# Town of Poughkeepsie

### A.5. 51 VASSAR ROAD

**SEQRA Review, Site Plan Review, and Architectural Review** for the redevelopment of a parcel to include construction of a ±10,640 square foot building for retail use. 51 Vassar Road; Red Oaks Mill Neighborhood Services Center (ROMNSC) Zoning District; ±4.58 acres; Grid #: 6260-04-565213; Unlisted Action; *Calito Development Group, LLC c/o Matt Eucalito (Applicant) and Oak Mill Plaza LLC c/o Vincent Destaso (Owner)*.

**Re: Amended Site Plan for Calito Development Group, LLC**  
**51 Vassar Road, Poughkeepsie, NY 12603**  
**Parcel ID #134689-6260-04-565213**

7 WB-67 TRUCK MOVEMENT  
1" = 40'

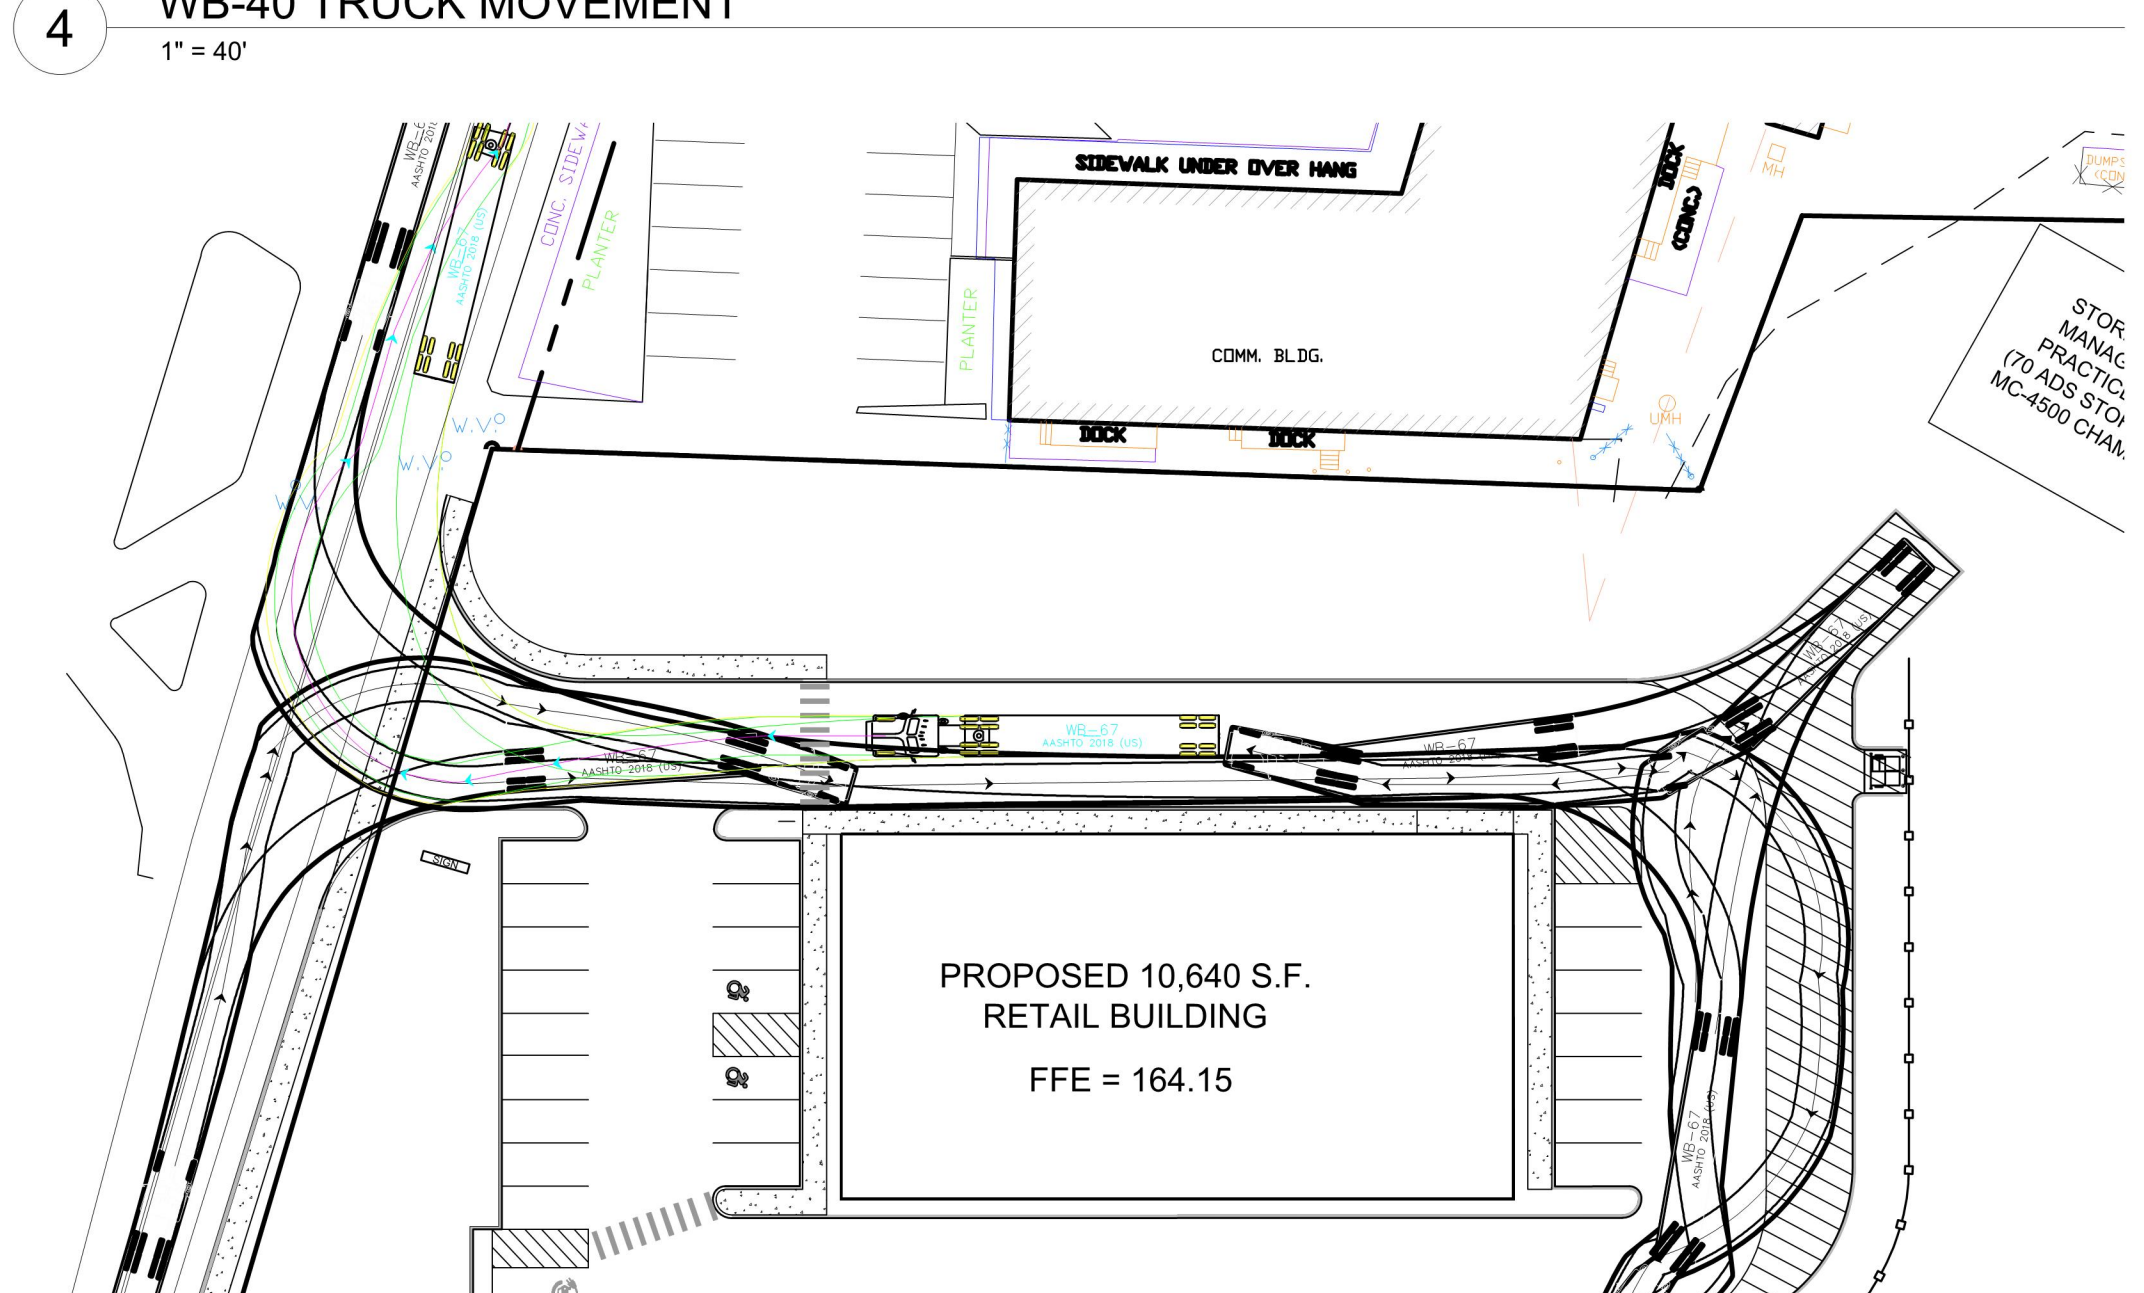
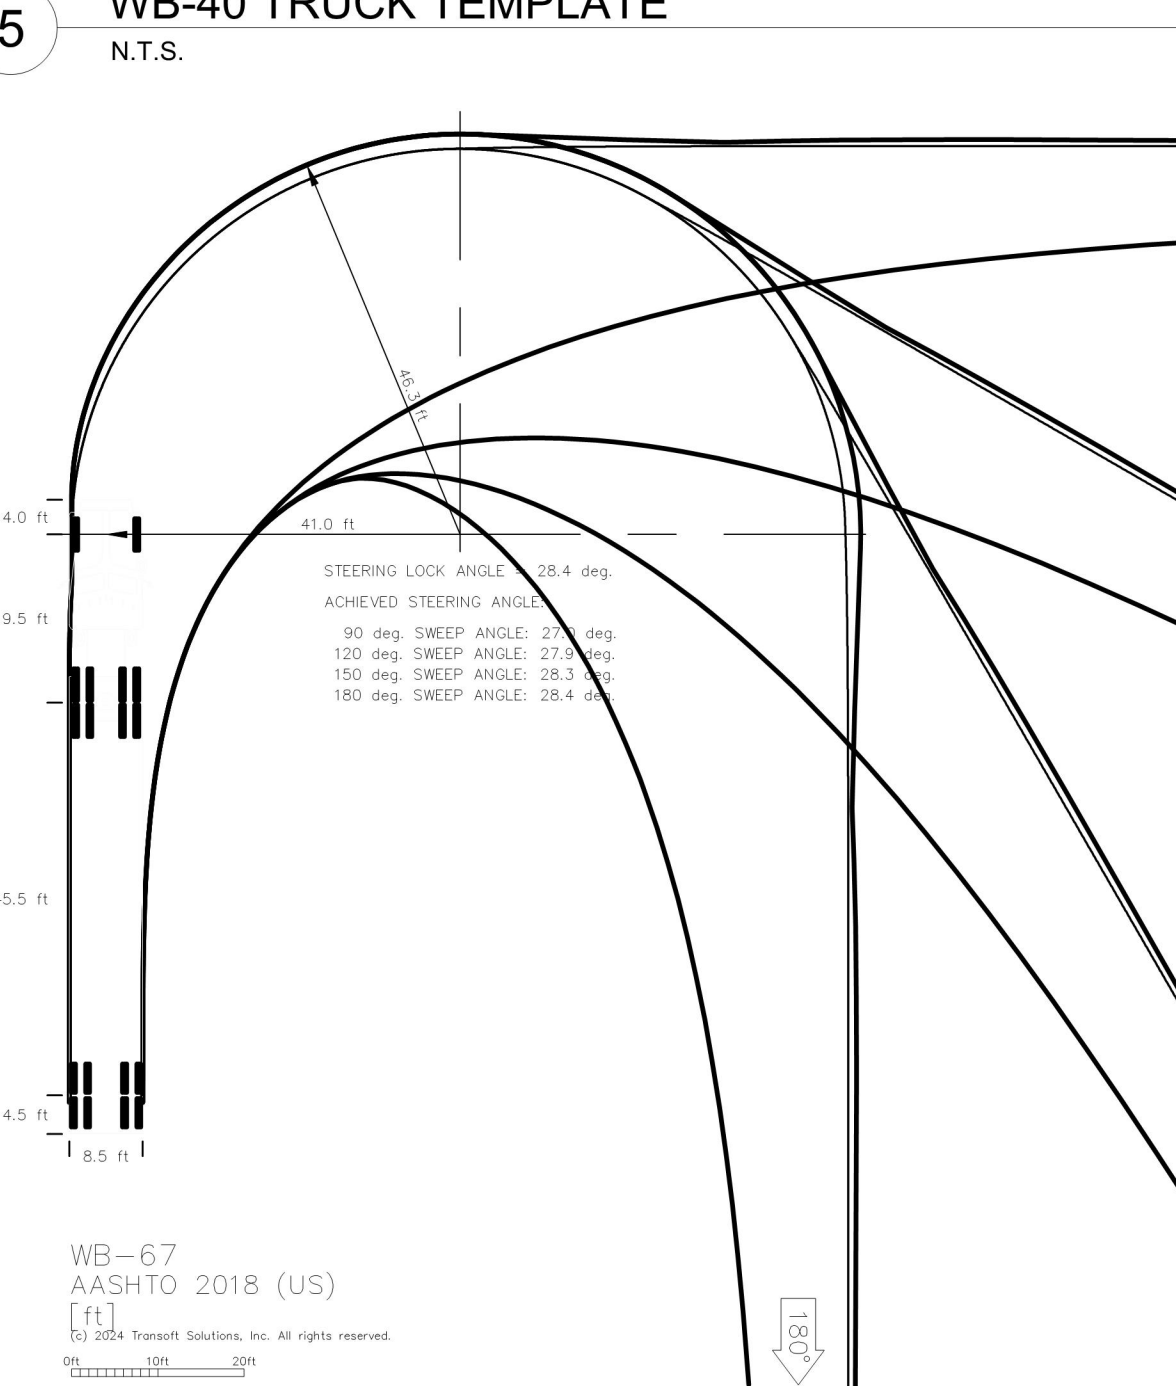
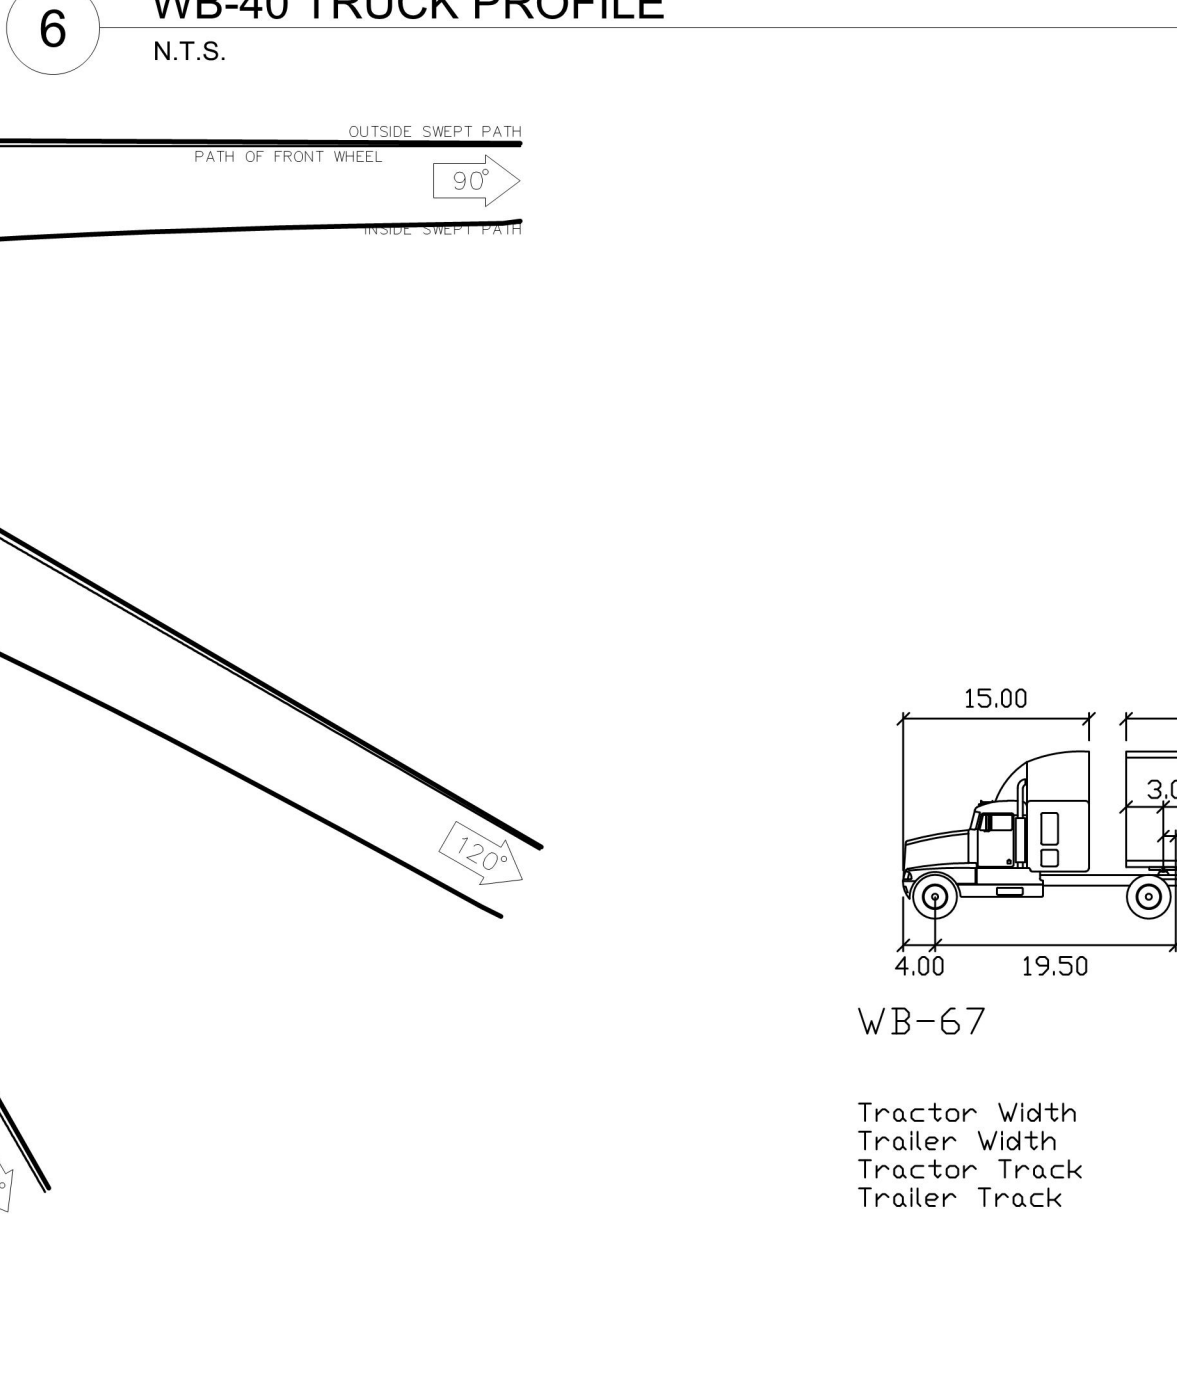
12. Sheet CS102: Applicant to confirm that they anticipate receiving WB-67 vehicles on site.
  - a. Appropriate coordination with DCDPW is required about turning movements into and out of the property. The need for larger vehicles to cross multiple lanes on Vassar Road in order to accommodate said turning movements should be discussed.

- *Applicant notes in their response to comments that consultation with DCDPW is ongoing. Staff request confirmation from DCDPW in writing.*
  - b. Vassar Road lanes to be shown for all circulation paths.

- *Applicant notes in their response to comments that the lines are included. Staff note that the only lines present are those of driveways. Staff are specifically looking for lane markings too.*

**Response: Correspondence will be forwarded if and when received.**

**Response: The line color has been revised to better plot on hard copies of the plan.**

10 SIGHT DISTANCE  
1" = 40'

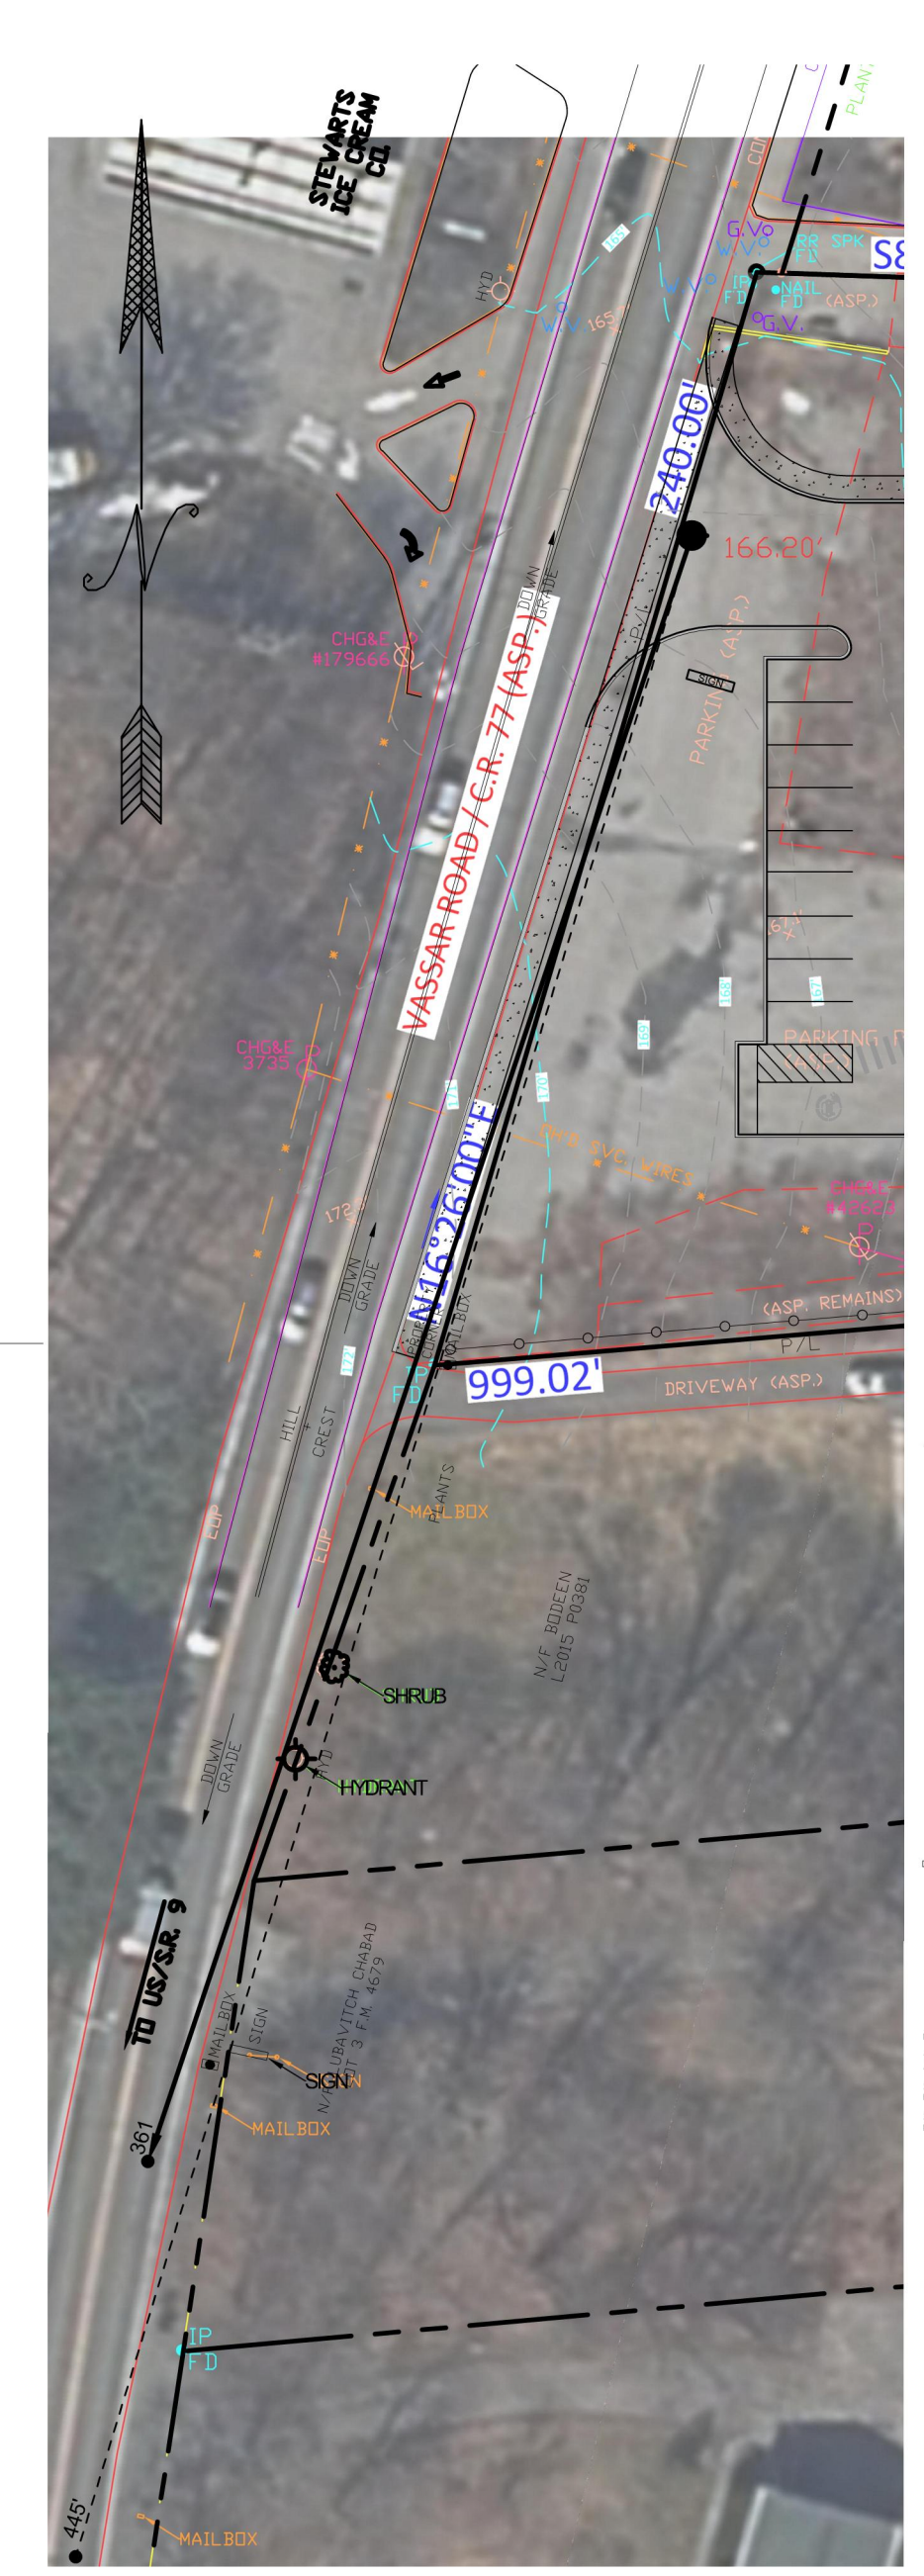
7. Response to prior Comment No. 7 is noted, the comment has been revised. The sight distance measurement as provided with the DC DPW Certification should be identified on the Landscaping Plan or Detail 10/CS102. It is unclear if the proposed landscaping will impact sight lines.

10. Response to prior Comment No. 10 is noted, the comment remains. The sight distance measurement as provided with the DC DPW Certification should be identified on the Site Plan and Landscaping Plan.

**Response: The sight distance now provided on sheet CS102 with an overlay of the area from satellite imagery.**

**Response: The surveyor has verified the measurements and provided an updated certification, included on sheet CS102.**

2 MONUMENT SIGN DETAILS  
NOT TO SCALE

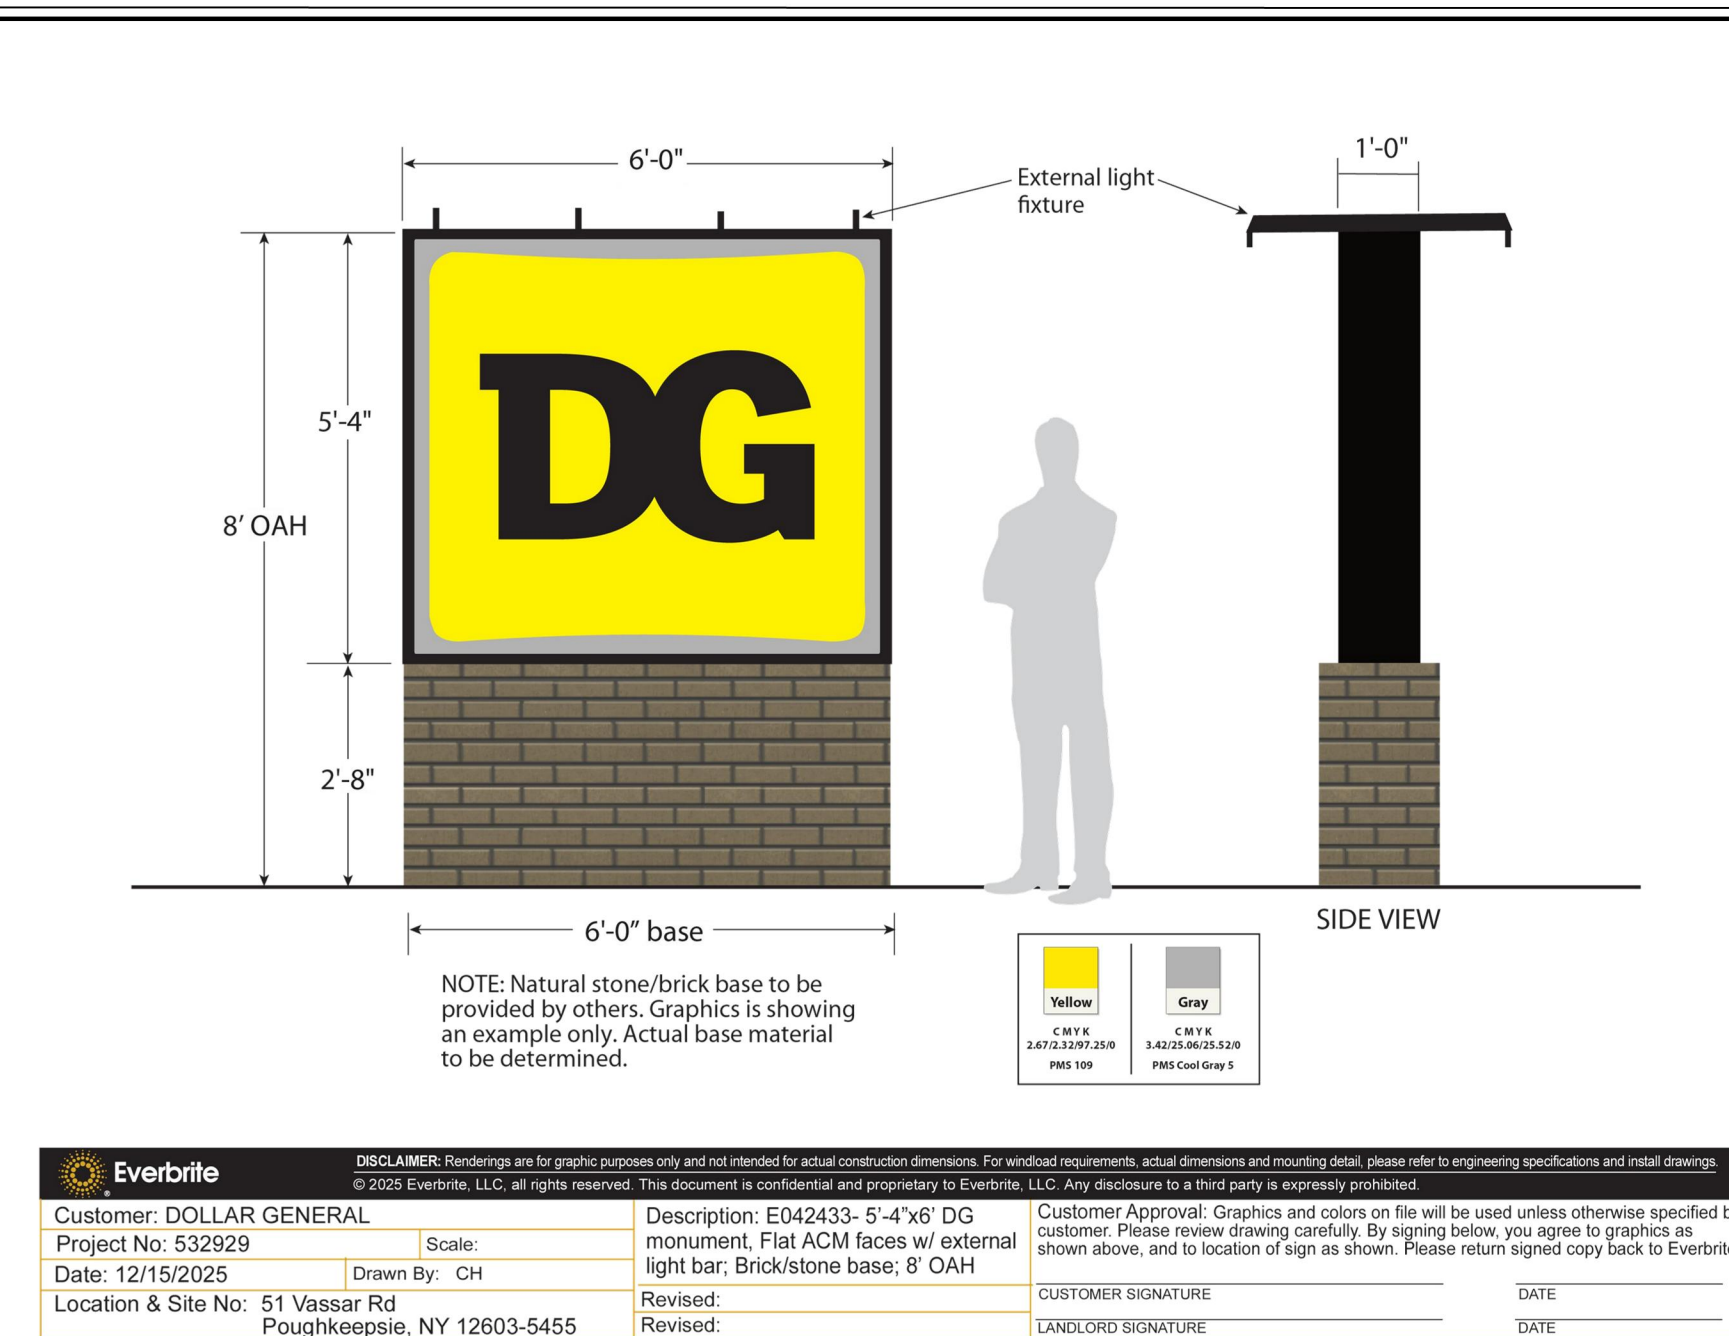
13. Sheet CS502: Applicant to confirm that an eight (8) foot monument sign is necessary. Although the sign is permitted by Town Code, the building front will include a wall sign with the business name.

- a. Applicant to note that there is a tree proposed near this monument sign that may hinder visibility. Confirm planting locations here.
14. Sheet LL101: The photometrics plan sheet appears incomplete. Applicant to provide photometrics to the property line. Applicant to review outputs at the southeast corner of the lot. Per Town Code §210-81, the cutoff for this parcel at the property line is 0.2 footcandles. However, the property to the south of this parcel is located in the R-20 zoning district and therefore consideration to get the footcandles to 0.0 should be given.
